# Cortez - U.S. 160 MM 46.42 Elevation ≈ 5900'

# **CDOT Region #5**

## **Summary Observations**

ADA compliant parking

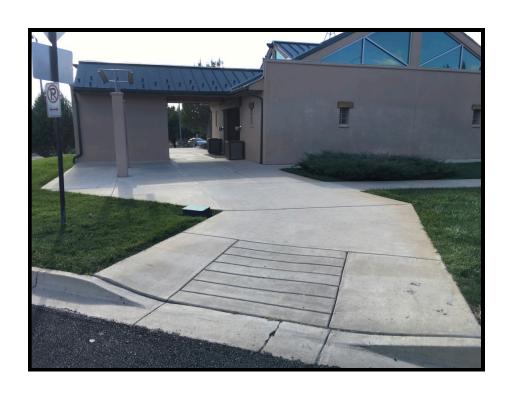
There are two separate parking areas. The east parking has **20 total parking spaces**, two of which are designated accessible parking spaces with one of the two, 'van' space. The west parking area has **16 parking spaces**, 2 accessible spaces with one designated 'van' space. Both 'van' spaces have the required 8' access aisle. These two parking areas meet the ADA scoping requirements (1:25) as there are 4 accessible parking spaces for the **36 total spaces**.
